ORDERS UNDER SECTION 96 (2) OF ACT, III OF 1901.

With reference to his application, dated 10th April 1917.
 Messrs Ralli Brothers is informed
 that the plan submitted by him for building a shed
 on plot No. 4, Survey Sheet BK
 situate in Wood Street, Railway
 Quarter, is approved, and permission to build in accordance therewith is
 granted. The building to be erected subject to the Bye-laws and Rules of the
 Municipality.

Showing proposed structures on No 4-B.2.

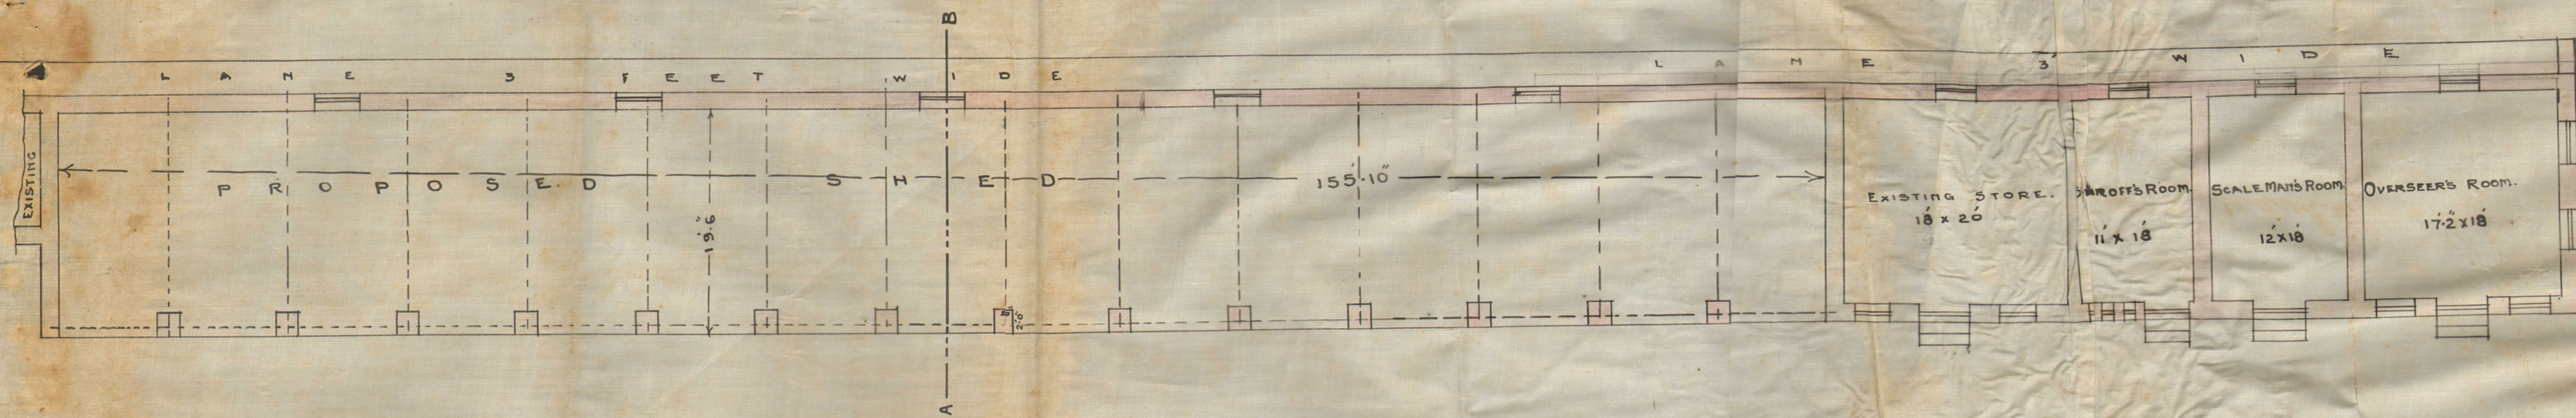
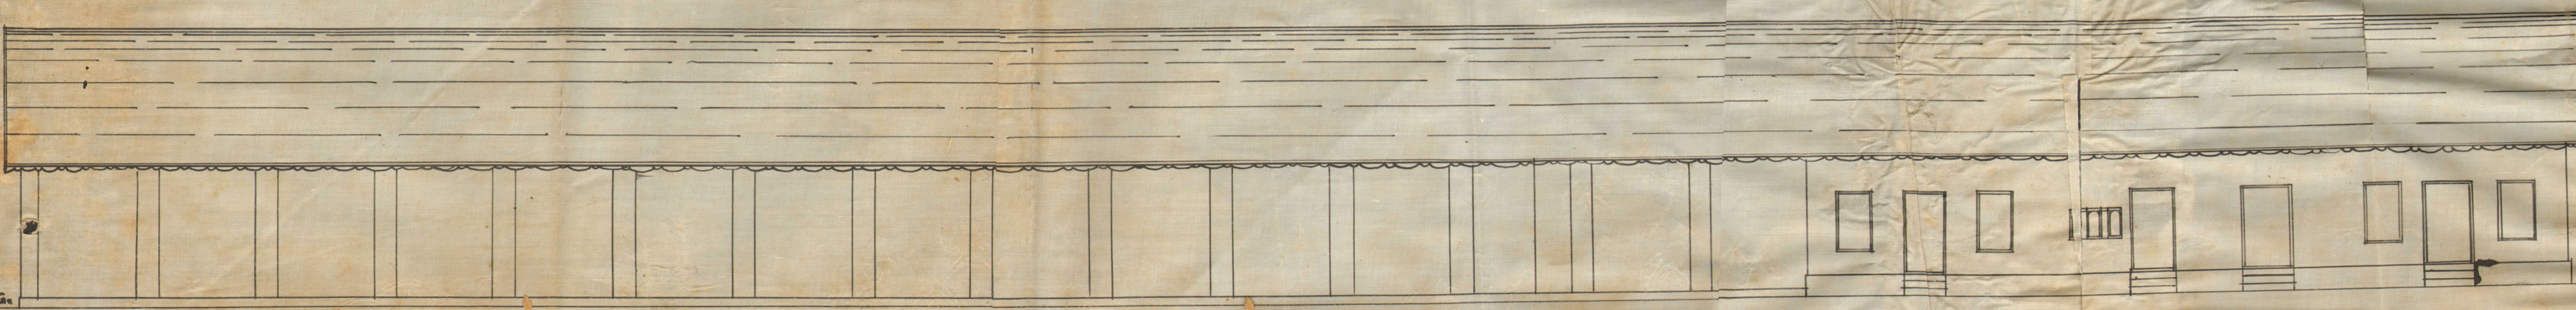
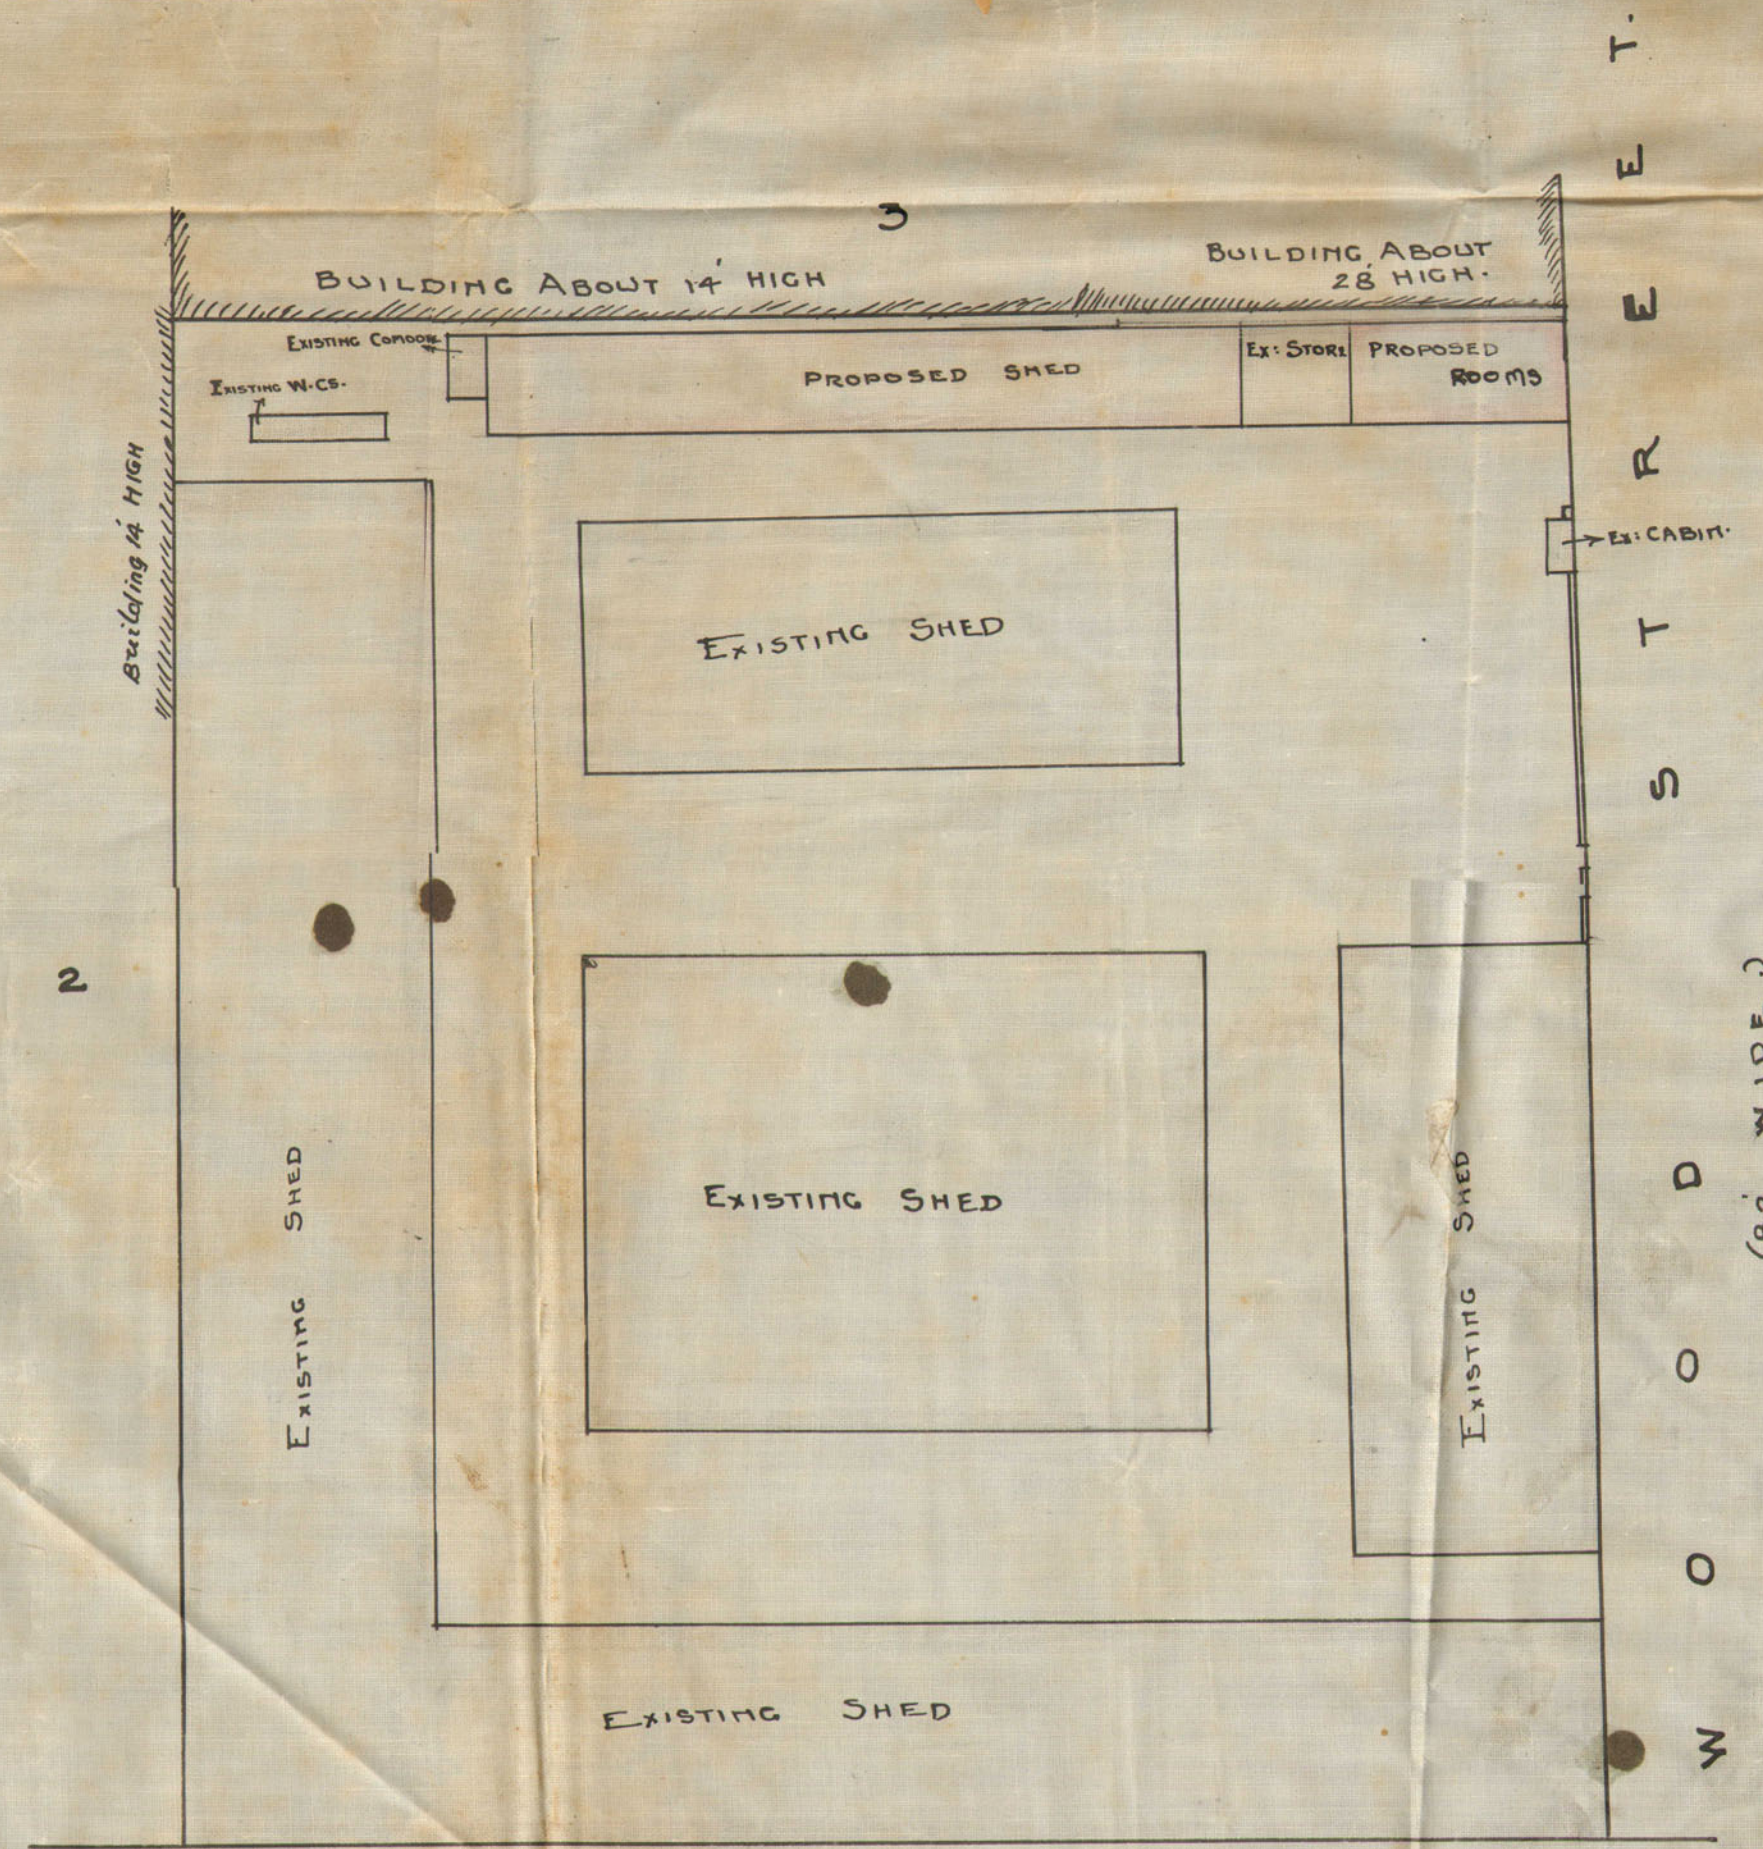
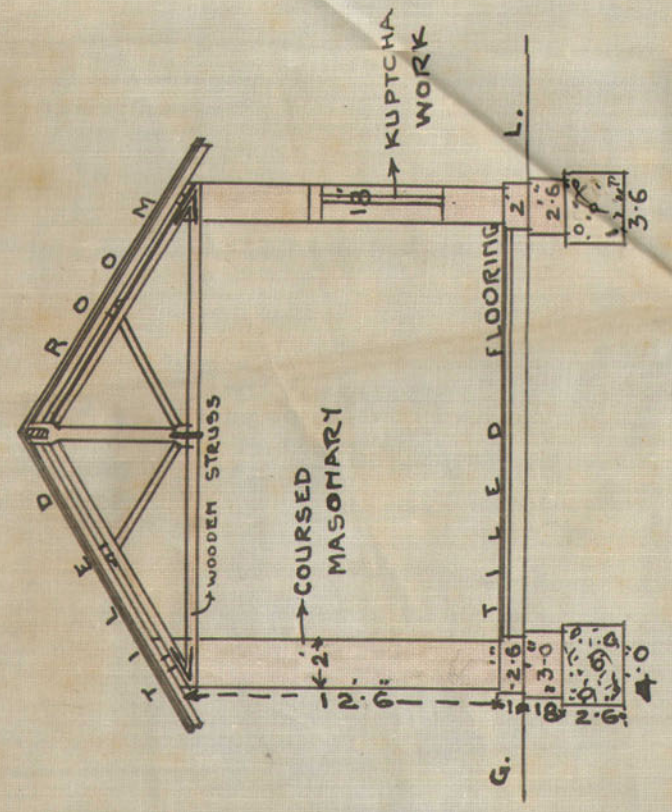
Considering that the shed will be entirely opened in front we should be obliged if you would let us know whether the windows to the North side of it referred to in your above letter, will still be required.

With reference to your letter dated 19th instant regarding building on plot No. 4, B-2 Railway Quarter I have the honour to inform you that the open space to the North should not be less than 3'-0" wide. The shed should have windows to the North.

The open space to the North should not
be less than 3'-0" wide. The shed should
have windows to the north.

Referring to your letter of 4th May 1917
with a set of amended plan. Please
the honor to inform you that the
3'-0" opening to the work will be done
as stated in this spec. no. E 34549
26 April is essential & must be provided
27. ~~The plan as returned herewith for a second~~
~~accordance~~ as shown in the plan.

Yes! 3'-5" opening for
ventilation is
essential.
